ECN - Tekniskt ändringsmeddelande
ECN-S04838
Datum: 2025-03-31
Utfärdare: Fredrik Nyblom

UPPDATERING ELBROMS REAL 9000 PLUS

ECN - Engineering Change Notice
ECN-S04838
Date: 2025-03-31
Issued by: Fredrik Nyblom

UPDATE OF THE ELECTRIC BRAKE REAL 9000 PLUS

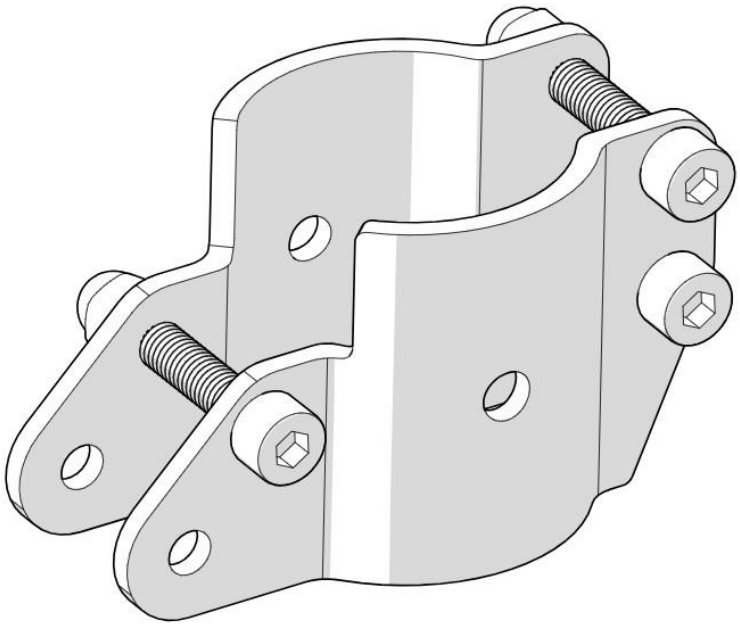
Elbroms Centrumfäste 9000 f Eldon till REAL 9000 Plus har reviderats för enklare montering.

Denna artikel har varit onödigt knepig att både tillverka och montera historiskt. Detta på grund av svetsmuttrarna som inte alltid satt rakt samt att formen på bockningen varit svår att få lika.

- Tillverkningsprocessen är ändrad till pressning i stället för kantpress.
- Svetsmuttrarna är ändrade till gängor och hattmuttrar.
- Tjockleken på plåten är ändrad från 3 till 4 mm.

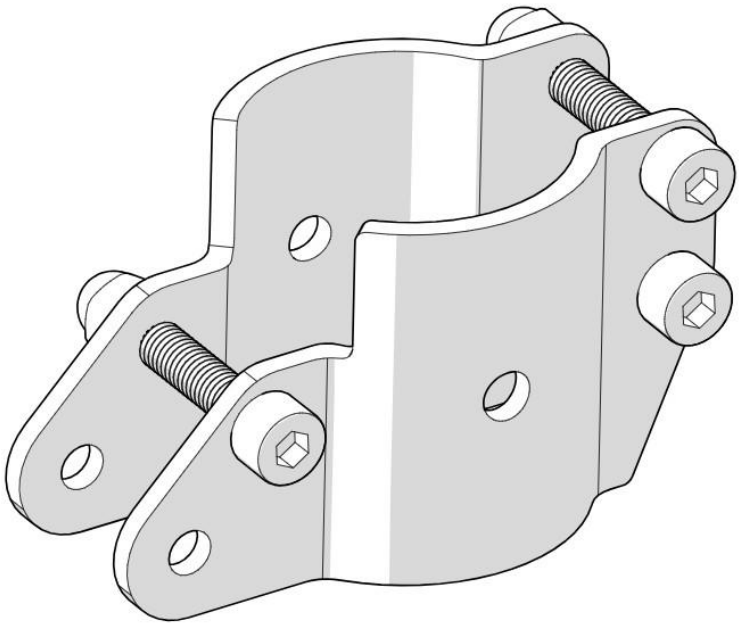
El. brake Centre attachment 9000 f electric kit for REAL 9000 Plus has been revised for easier assembly.

This item has historically been unnecessarily tricky to both produce and assemble. This is due to the weld nuts not always being properly aligned and the shape of the bending being difficult to make consistent.

- The manufacturing process has been changed to pressing instead of using a press brake.
- The weld nuts have been replaced with threads and cap nuts.
- The sheet metal thickness has been changed from 3 to 4 mm.
